North Westerly - PD zoning 3rd Review

To: John Prestwich, PCS Group
From: Aly Burkhalter, Senior Planner
Date: January 16, 2025
Re: PD-001700-2024 North Westerly - PD

3rd Review & Referral Comments

UTILITY CONCEPT PLAN

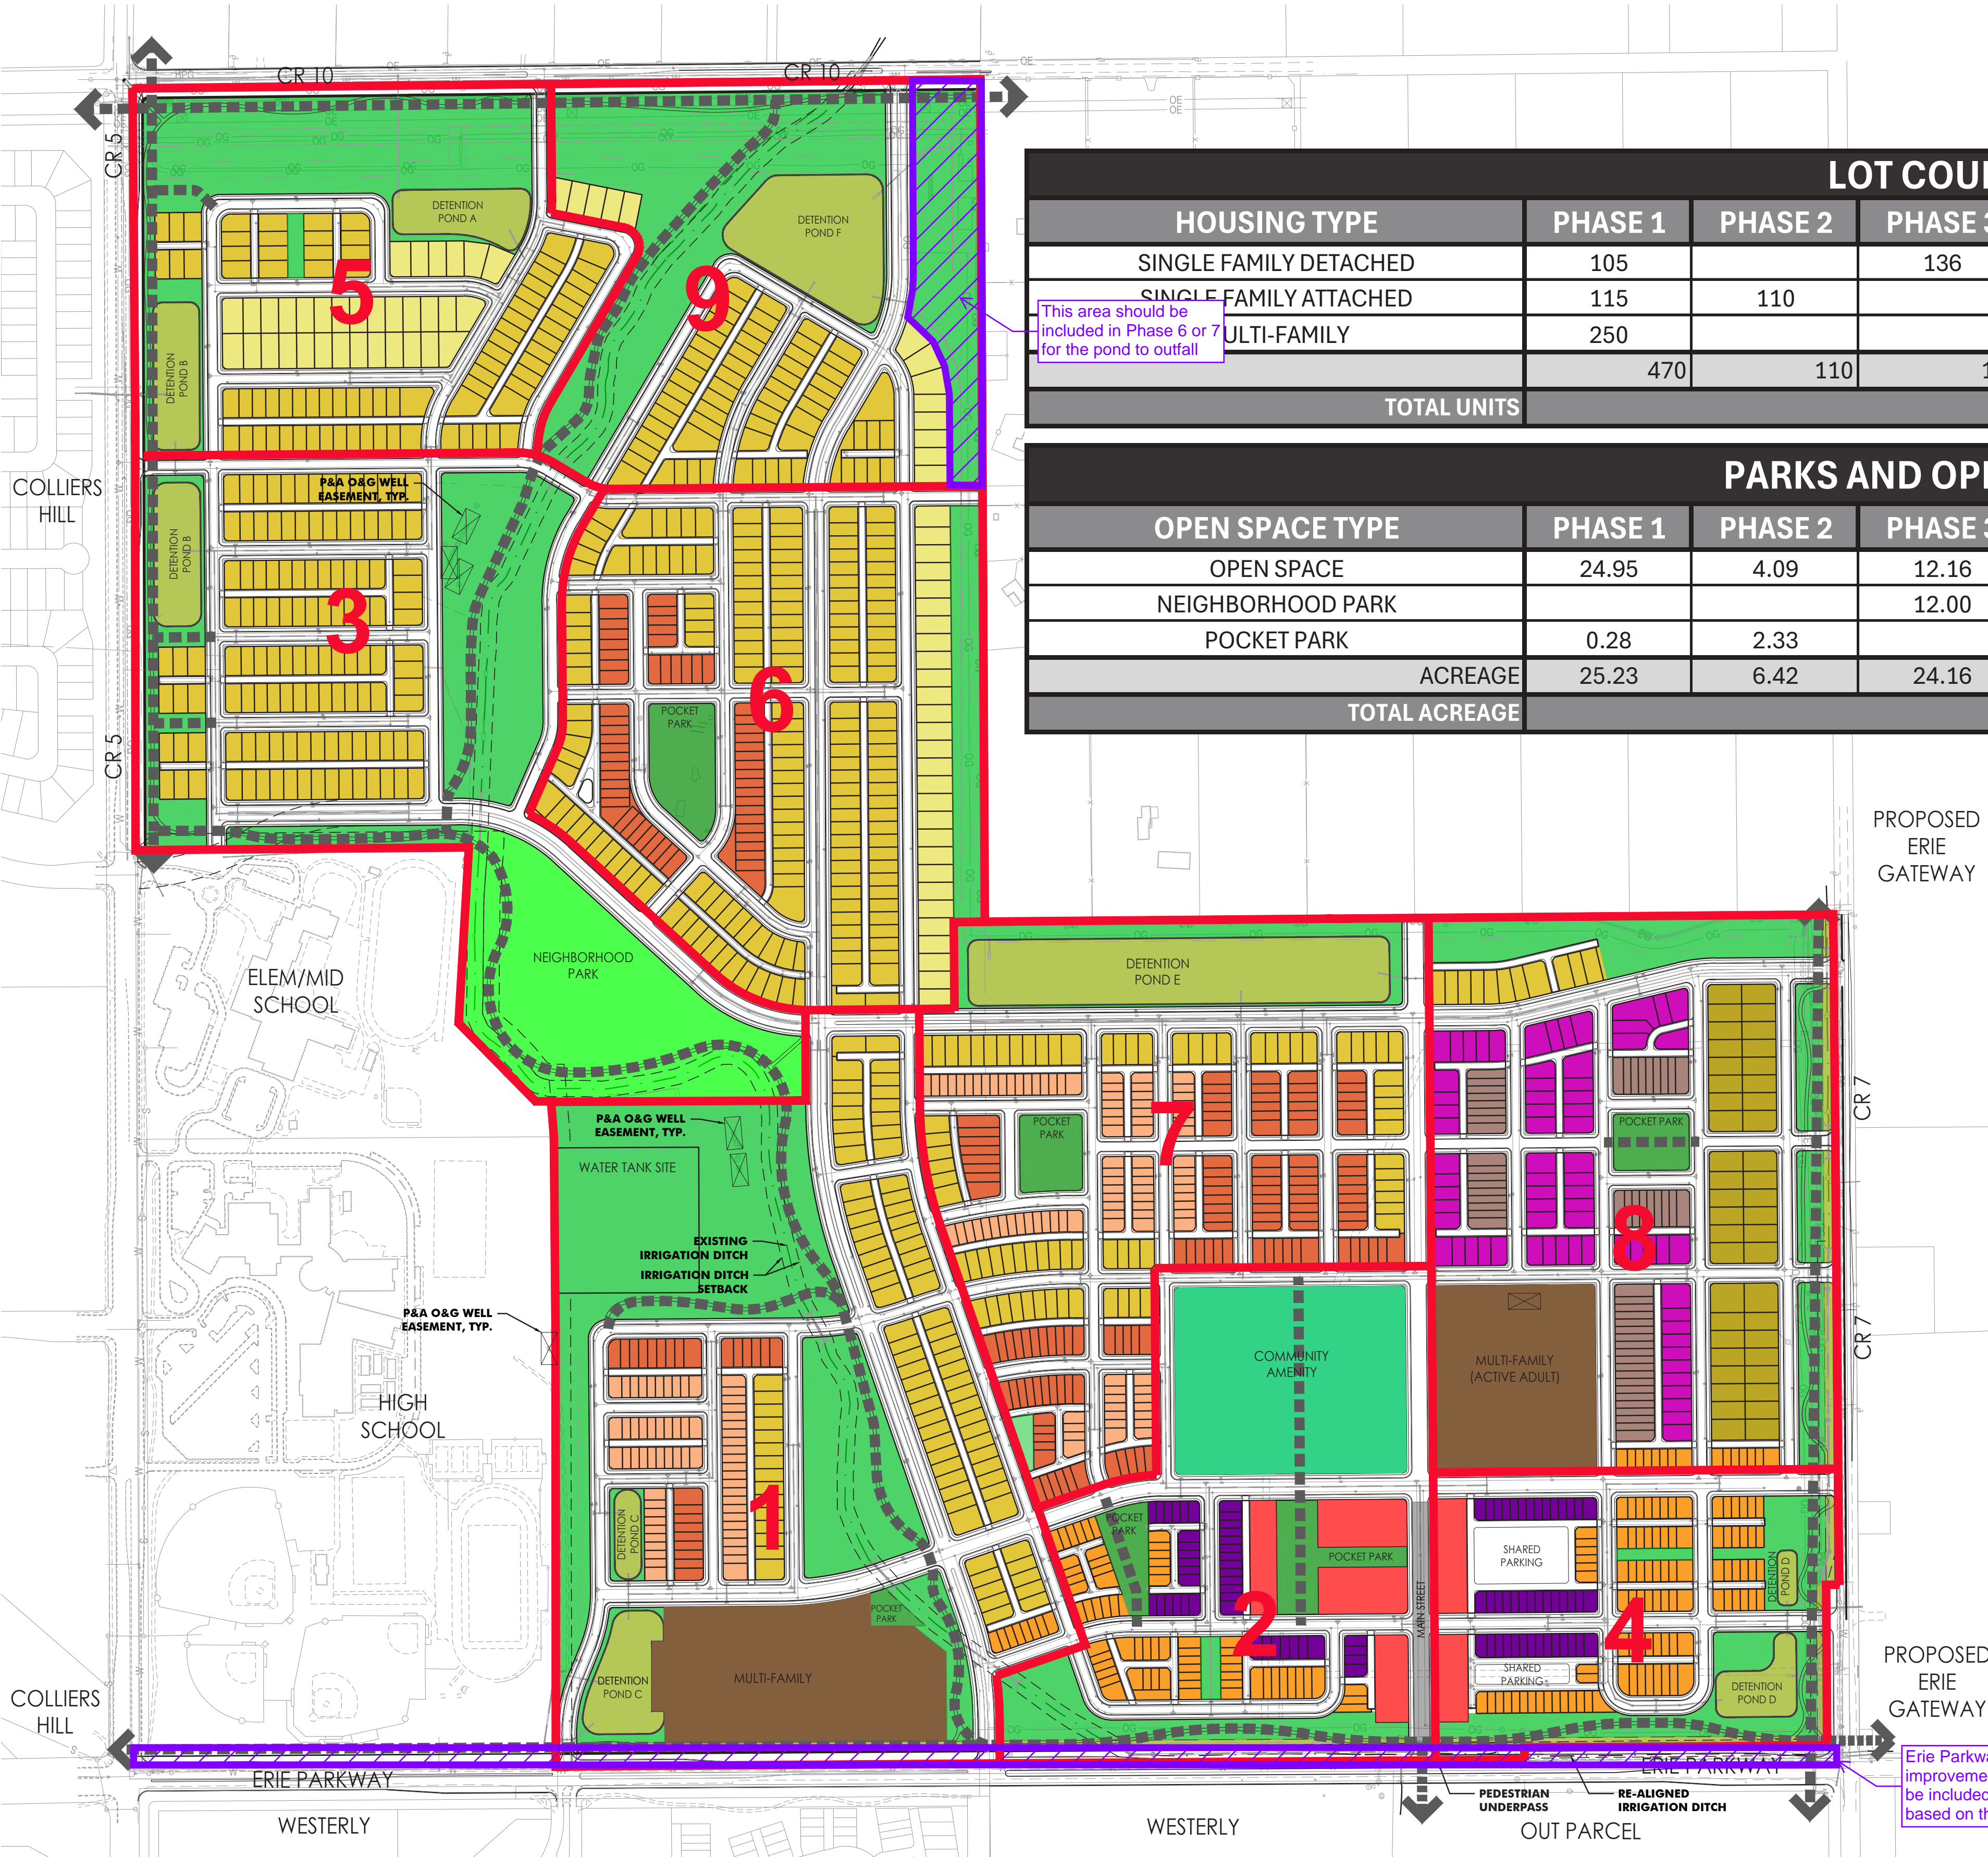
5. Sheet 11:
 - a. The drainage plan shows Pond F outfalling into the swale at a different location. Please make sure what is shown on the utility concept plan and drainage plan are consistent.

Sheet 14 - Circulation Plan and Typical Road Sections:

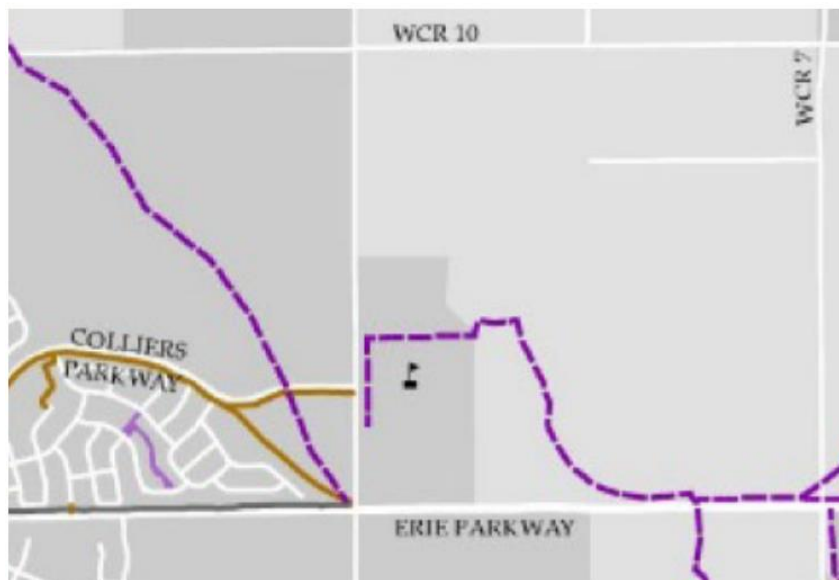
2. Show trails on this map in order to understand how the trail system and the street network correlate. It is the intent for the Town to take over maintenance of the multi-use trail system as part of its spine trail system and should be shown differently than internal local connectors.

Response: We have included a trails map.

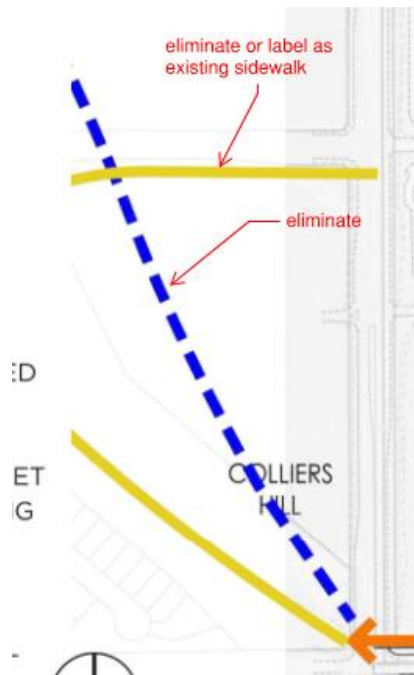
TOE: The existing Spine Trail on the west side of WCR5, south of WCR 10 needs to be shown. Also make the following revisions at the NW corner of WCR5 & Erie Parkway as shown below.

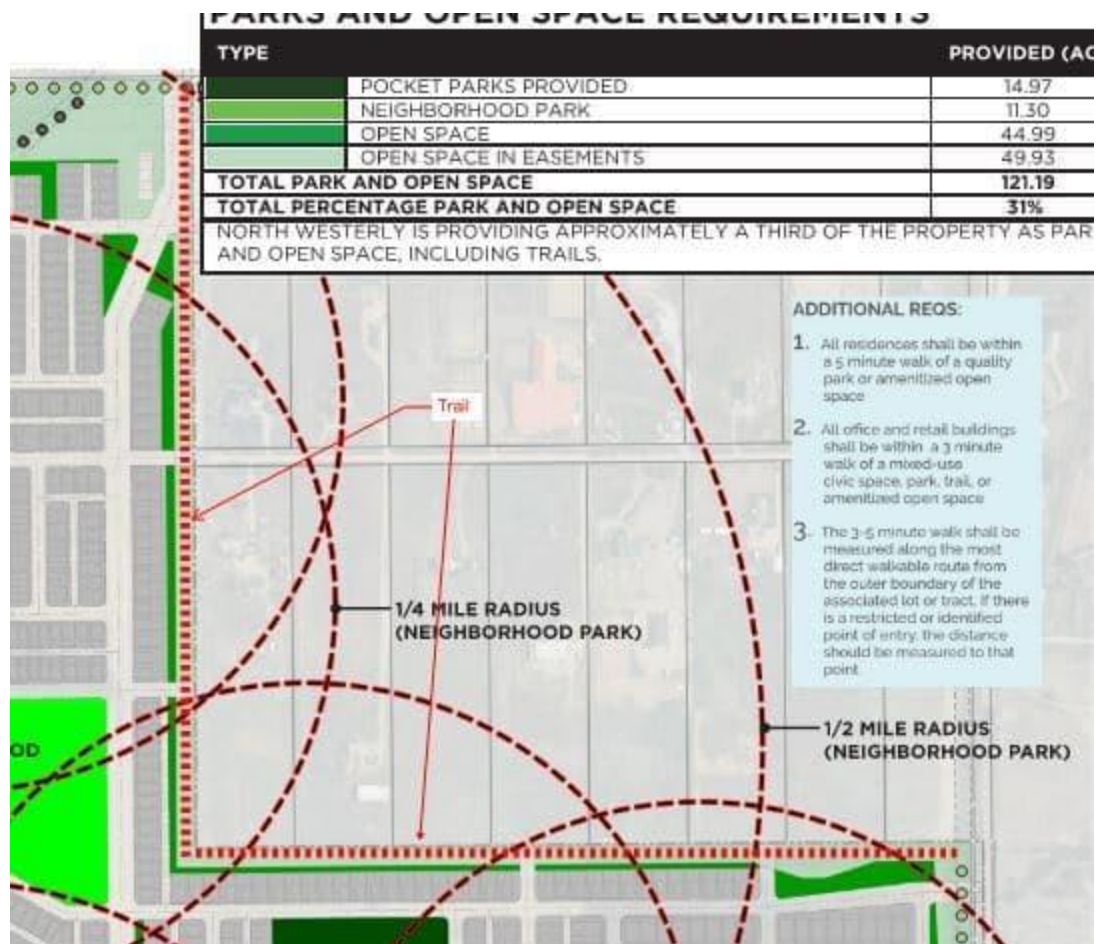
4. Provide an east/west trail connection from the Flora View Drive Intersection to the Neighborhood Park. See below.

Response: This trail connection has been provided.
